# Access Compliance Report

## Public Rights-of-Way

### (Curb Ramps)

Intersection ID: 52931	Main Street: WALTHAM_LN	Cross Street: GRAY_OAK_LN	Location: E
ADA ID: CE38959105B1	Ramp Type: Perp	Initial Pass/Fail: Fail	Overall Compliance: No
Severity Score: 21.25			
Codes/Mitigation Info/Possible Solution		Field Measurements/Component Compliance

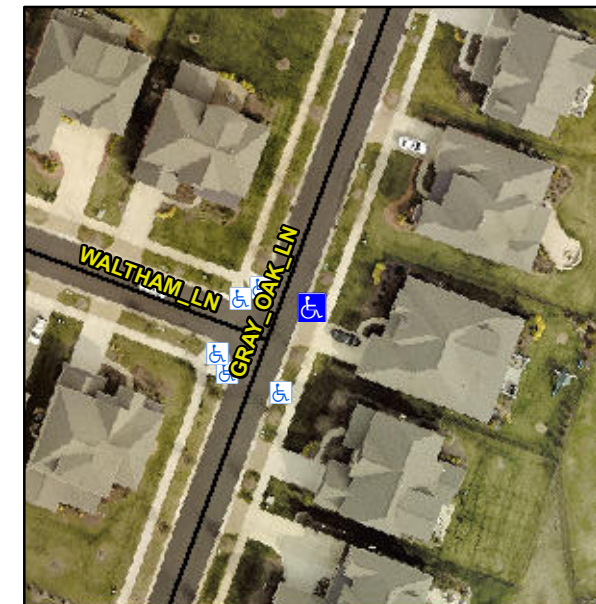
**Not Found, R304.5.1, R304.2.2**

Compliance	Description	Data	Compliance	Description	Data
N/A	Ramp Length (in)	95.0	No	Ramp Slope (%)	9.6
No	Ramp Width (in)	47.0	Yes	Ramp XSlope (%)	0.6
N/A	Flare Type LT	N/A	N/A	Flare Type RT	N/A
N/A	Flare Slope LT (%)	N/A	N/A	Flare Slope RT (%)	N/A
N/A	Flare Traversable LT?	N/A	N/A	Flare Traversable RT?	N/A
N/A	Landing Length (in)	N/A	N/A	DWS Provided?	N/A
N/A	Landing Width (in)	N/A	N/A	DWS Contrast?	N/A
N/A	Landing Slope (%)	N/A	N/A	DWS Length (in)	N/A
N/A	Landing X Slope (%)	N/A	N/A	DWS Full Width?	N/A
N/A	Landing Curb? (Y/N)	N/A	N/A	DWS Offset (in)	N/A
N/A	Shared Landing?	N/A			
N/A	Gutter Ponding?	N/A	N/A	Gutter Slope (%)	N/A
N/A	Gutter Lip Ht (in)	N/A	N/A	Gutter X Slope (%)	N/A
N/A	Painted X Walk1?	No	N/A	Painted X Walk2?	N/A
	X Walk 1 Direction	To NW		X Walk 2 Direction	N/A
N/A	X Walk 1 Width (in)	N/A	N/A	X Walk 2 Width (in)	N/A
	X Walk 1 Slope (%)	3.8		X Walk 2 Slope (%)	N/A
	X Walk 1 X Slope (%)	2.6		X Walk 2 X Slope (%)	N/A

**Remove & Replace Entire Ramp.**
